COLLAR BUSH - SMALL

DRG.No.: CWM 05822

ALT.No.: 1

S & T WORKSHOP, S.RLY, PODANUR.

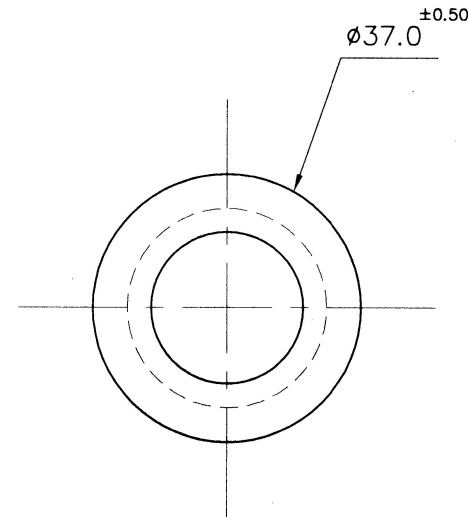
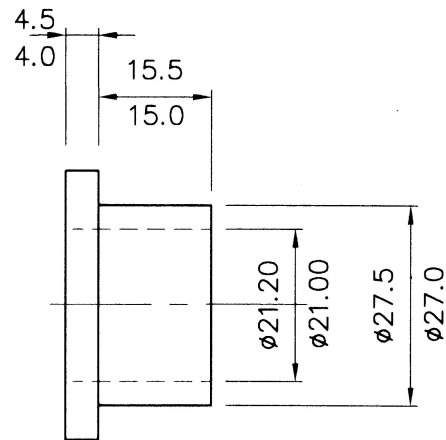
1. DIA DECREASED FROM 40mm TO 37
2. THICKNESS OF COLLAR INCREASED FROM 3.5/3.0 TO 4.5/4.0
